PROJECT: WALDEN CORPORATION WWTP  
 3155 WALKER ROAD COLORADO SPRINGS  
 EL PASO COUNTY, COLORADO  
 ENGINEER: AQUAWORKS DBO, INC.  
 3252 WILLIAMS STREET  
 DENVER, COLORADO 80205  
 (303) 477-5915

SHEET TITLE:  
 LAGOONS CLOSURE PLAN  
 PROJECT NUMBER: #3774  
 SCALE: 1"=100'  
 SHEET: C10

# V3\_ Pond reclamation.pdf Markup Summary

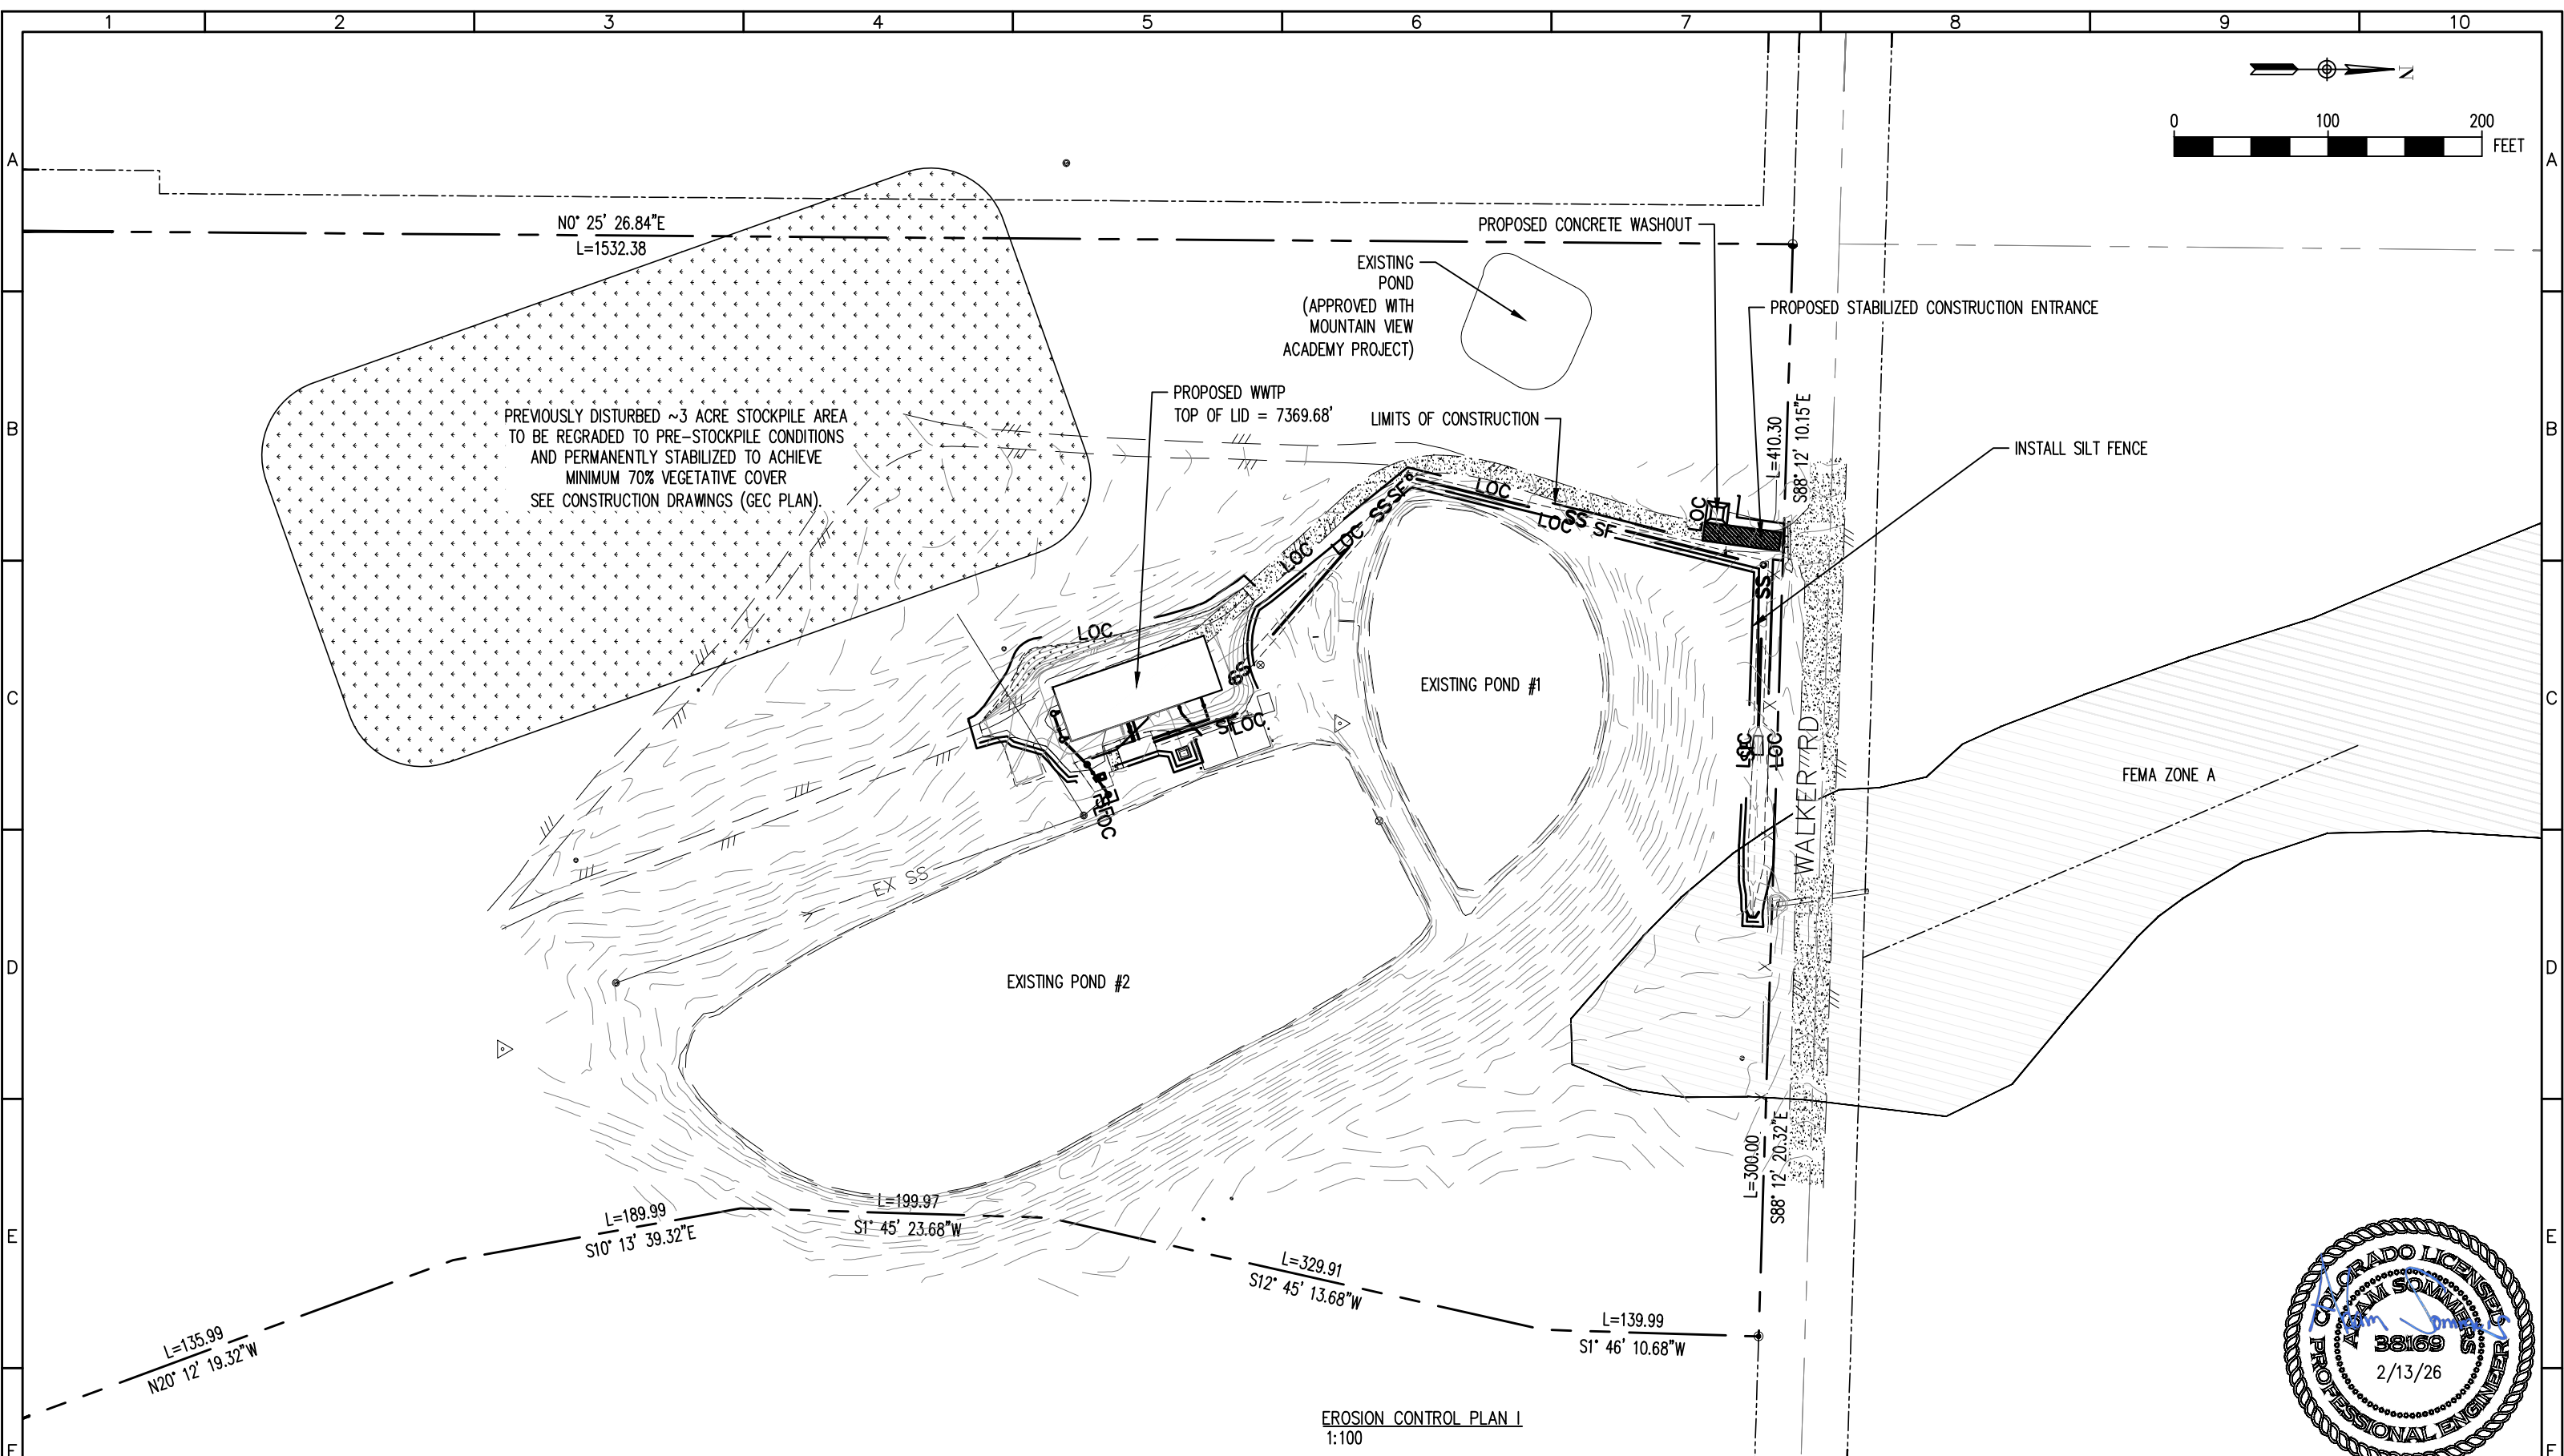
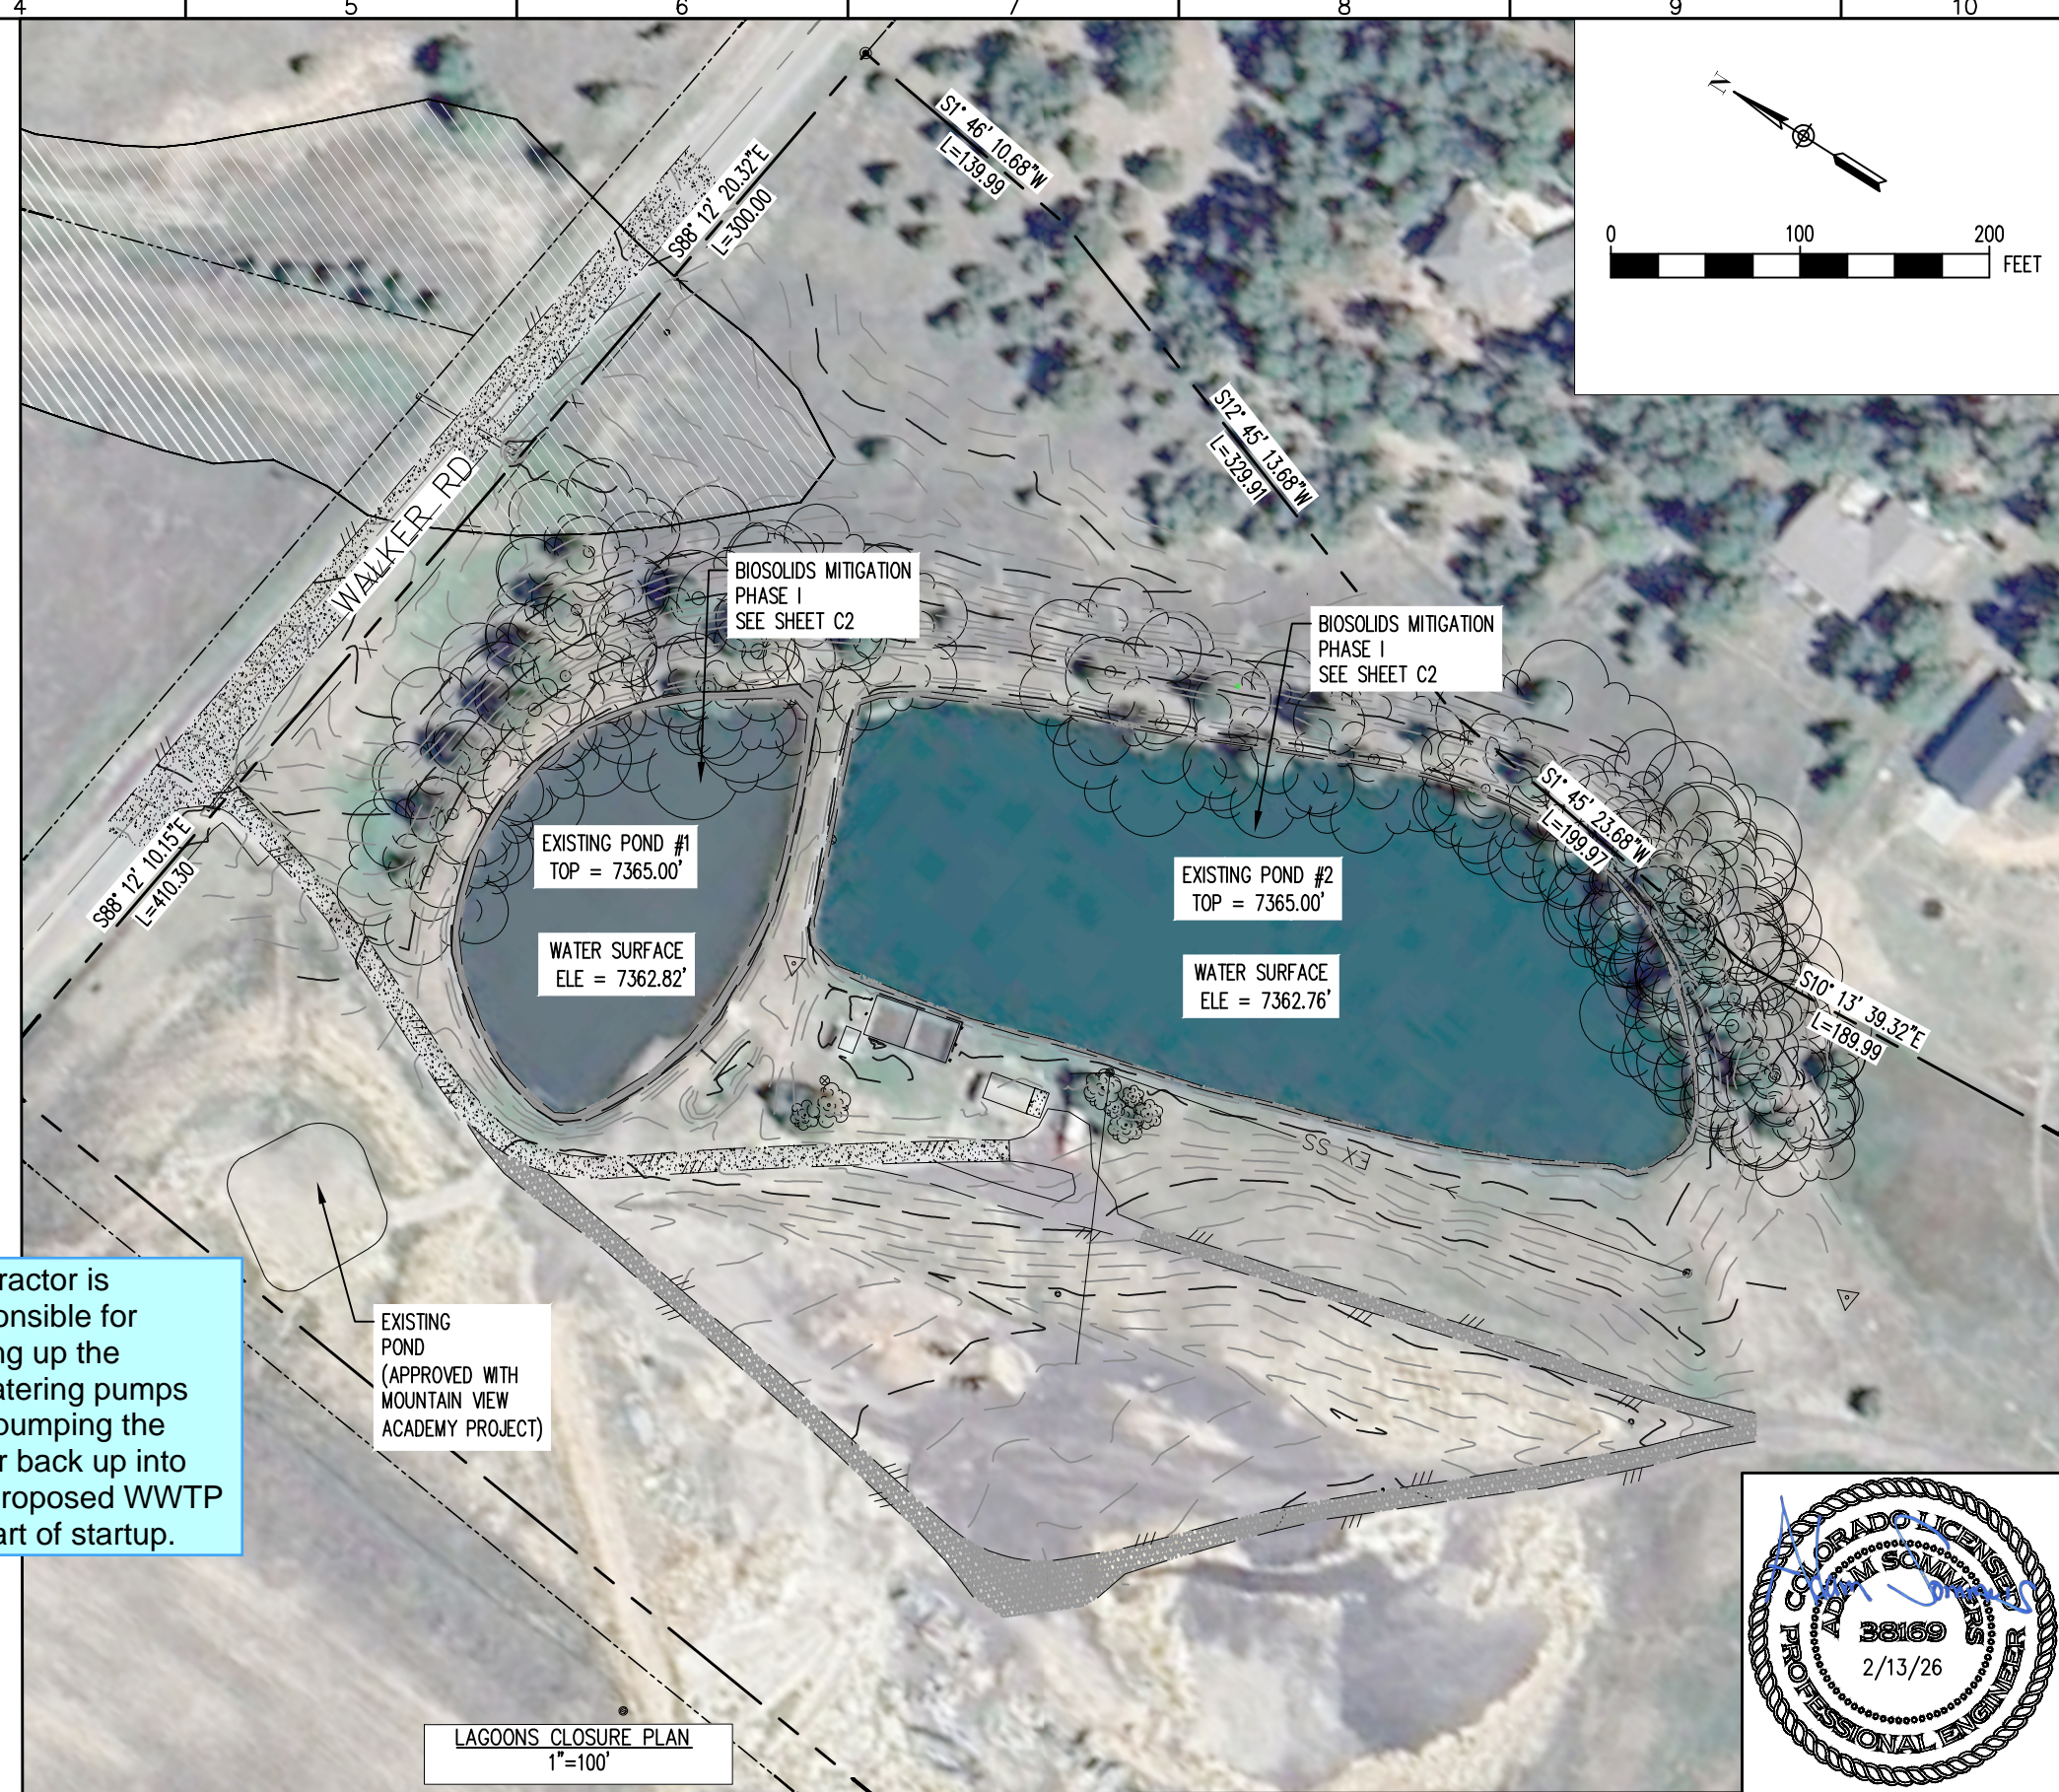
Show the anticipated dewatering operation on GEC plan and provide details.

See note on GEC plan. Reclamation plan must match GEC plan.

Please include a sheet of the pond in its final reclaimed state, including vegetation, pipes, and grading,

Contractor is responsible for setting up the dewatering pumps and pumping the water back up into the proposed WWTP as part of startup.

Sheet showing ponds in their final reclaimed state updated as per request.
